# State Significant Development Application - SSD 6554 Response to Submissions/Preferred Project

## Block 1, Central Park

### Mixed Use Residential Development

Submitted to Department of Planning and Environment  
On Behalf of Central Park JV No 2

**Figure 1** – Building Separation  
Source: Foster + Partners

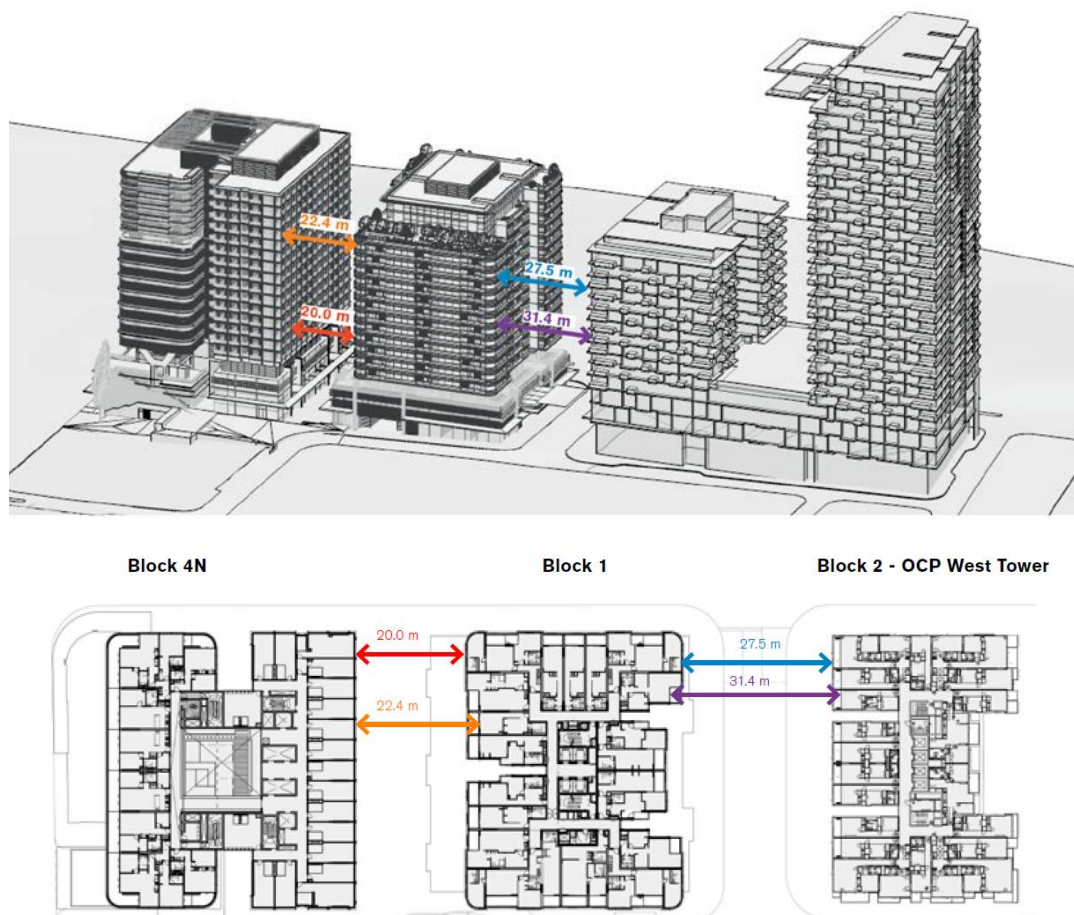
Concern was raised by the DPE that the current building presents a visual bulk and scale that is similar to a commercial building and inappropriate for a residential flat building. Within their submission, CoS contends that the building envelope established within the Concept Plan cannot be fully realised for residential use, given the amenity that results, including building separation. The relevant sub issues associated with the building envelope are addressed below.

Following the progression of Block 4N (SSD current under assessment by the DPE), and further refinement of Block 1, the building separation distances between Block 1 and Block 4N, as well as Block 1 and the west tower of Block 2 have been refined. The revised separation distances are **Figure 1** below (as shown in the RTS report at **Appendix B**).

- Between Block 1 and Block 4N (west) – 22.4m from habitable room to façade of Block 4N
- Between Block 1 and Block 2 (east) – 31.4m (habitable to habitable rooms)

The separation distance between Block 1 and Block 4N (to the west) on a typical level (in the tower above nine storeys) is 22.4m from habitable room to the façade of Block 4N. This arrangement is consistent with the objectives of both the Residential Flat Design Code (RFDC) and draft Apartment Design Guidelines (ADG), providing substantial distance separation and suitable design responses to each of these elevations (screening devices to the Block 1 private open space).

**Figure 2** – Existing Approved and Proposed building envelopes

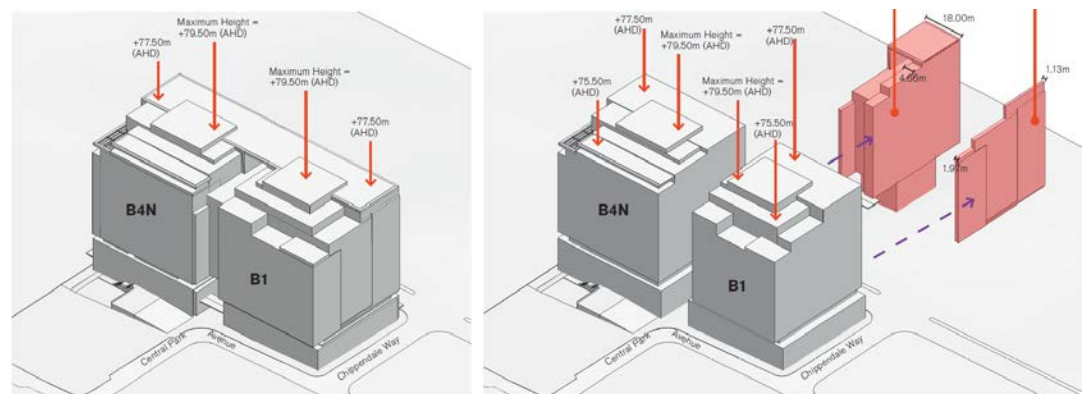
Concern was raised by the DPE that the building presents a visual bulk that is similar in scale to a commercial building. A response to this item has been provided by Foster + Partner in the RTS Report (**Appendix B**).

Specifically, the RTS Report establishes the progression of the commercial office scheme of the original Concept Plan through the proposed Block 1 residential envelope. Notably, as part of the Block 1 residential scheme (as subsequently Block 4N SSD), the bridge link that previously connect Block 1 +4N has been removed, significantly reducing the building envelope. As shown in **Figure 2** below, additional setbacks to the podium and eastern elevation have also come out of the transition to a residential scheme, all of which significantly reducing the visual impact of the building from Broadway and surrounding areas of public domain.

The resulting form and scale of the building envelope of Block 1 is similar to that of the adjacent west tower of Block 2 (One Central Park) and is in keeping with the intent of the Concept Plan to provide consistent streetscape to Broadway as the Gateway to the CBD (further discussed in Section 2.7 of the RTS Report – **Appendix B**). As discussed below (in **Section 2.13** of this RTS), given the articulation to form, particularly the inclusion of slots, the building envelope size (including depth) allows the achievement of high levels of amenity to apartments.

**Figure 5** – Location of habitable rooms  
 Source: Foster + Partners

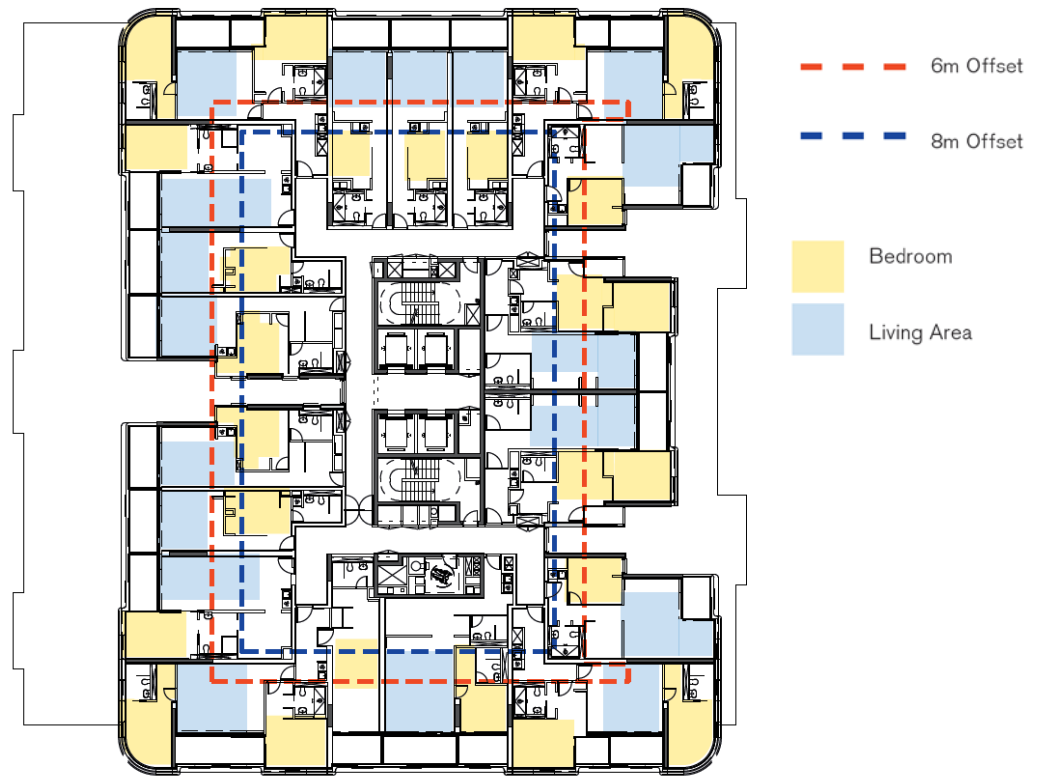
The DPE and Cos expressed a concern over the building depth, with reference to the impact the depth may have on the ability for the building to achieve suitable levels of amenity.

Noting the building's depth, the design development of Block 1 has consciously looked to locate the habitable rooms within 6.00m (in the case of the main living rooms) and 8.00m (in the case of bedrooms) of the façade, with an average apartment depth of 7.15m, consistent with the RFDC rules of thumb for apartment layouts. The arrangement of a typical floor, showing the relevant distances is shown below in **Figure 5**.

The apartment mix and orientation allows for deep apartment layout to be avoided and living areas located adjacent balconies and loggias, close to the façade to achieve daylight access and ventilation.

**Figure 6** – Natural cross flow ventilation  
Source: Foster + Partners

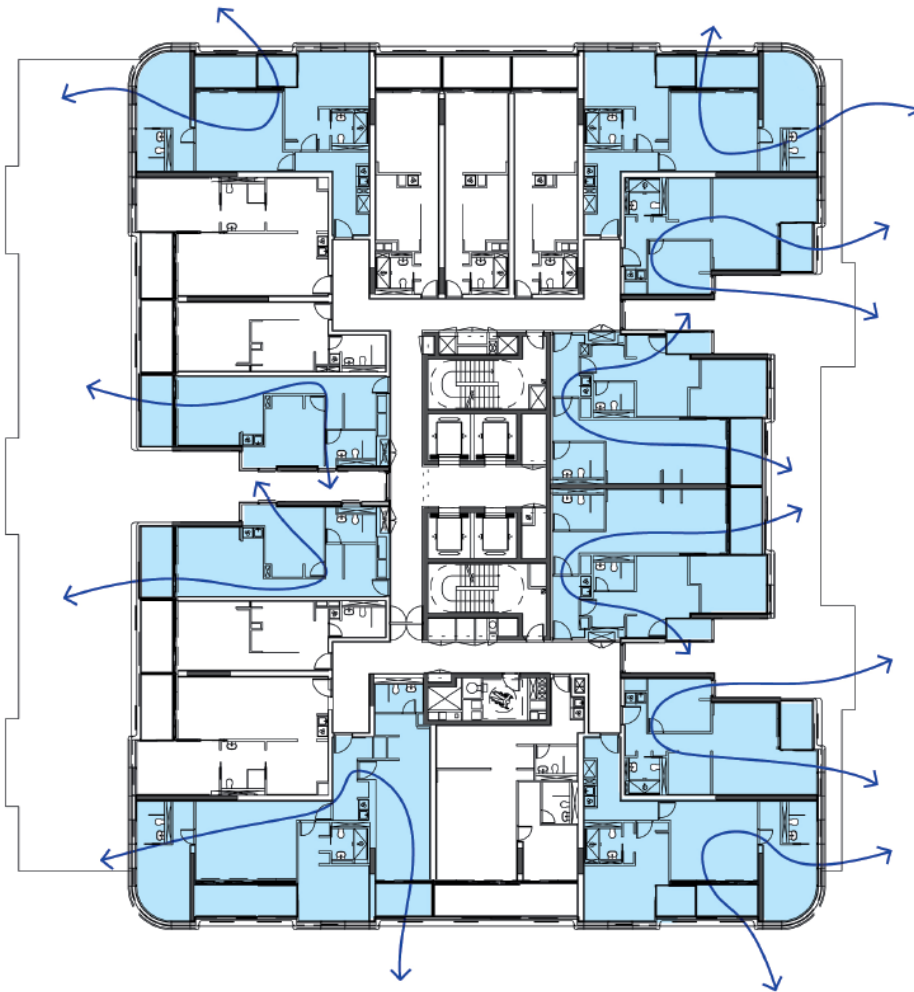
Concern was raised by CoS regarding the proposal ability to provide natural ventilation within the development.

All apartments within Block 1 are naturally ventilated. As detailed in the RTS Report (**Appendix B**) as well as the ESD Statement (submitted with the SSD), 56% of apartments are cross ventilated (see **Figure 6**), with a further 5% of the apartments achieving the same levels of thermal comfort and indoor air quality as an equivalent cross ventilated apartment.

Cross ventilation provides comfortable conditions for 66.9% of the year and the natural ventilation provides the same conditions for 65.4 % of the year. Modelling undertaken by WSP also demonstrated the levels of CO<sub>2</sub> when comparing a cross ventilation and natural ventilation scenario were approximately equal.
